Voluntary Recall of Wild Country Superlight Rocks

Name of Product: Wild Country Superlight Rocks Nos. 1-6 (code 40-RSL) and Superlight Rocks Set Nos. 1-6 (code 40-RSLSET) produced prior to January 2023.

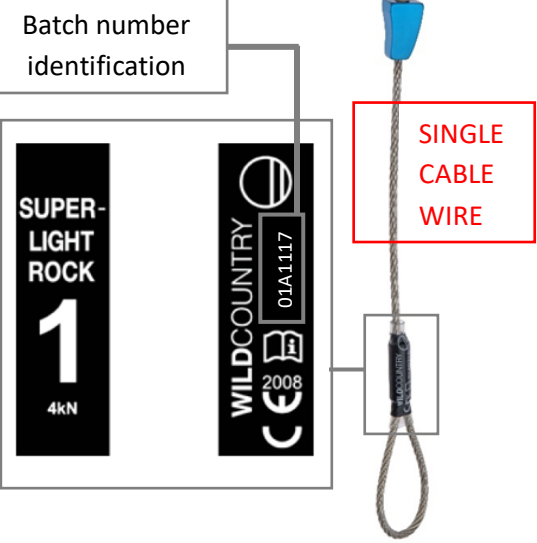
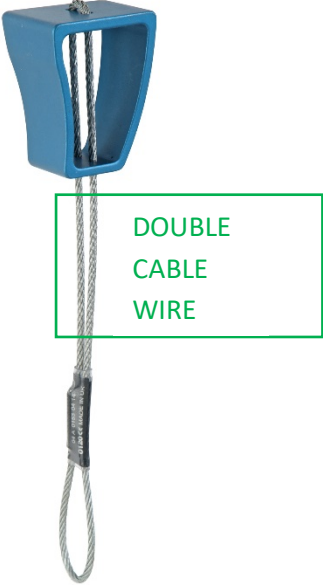
Hazard: Wild Country has recently learned that when single cable Superlight Rocks are exposed to maritime seaside conditions with high concentrations of salt, and/or humid climate with salty atmosphere for an extended period of time, corrosion inside of the ferrule (the swage covered in plastic that is labelled with the name of the product) can occur. This can significantly reduce the breaking strength of the chocks and may therefore become dangerous for a climber in the event of a fall from height.

Remedy: Dealers and consumers should immediately stop using all Superlight Rocks Nos. 1-6 and contact Wild Country **for instructions to obtain a replacement.**
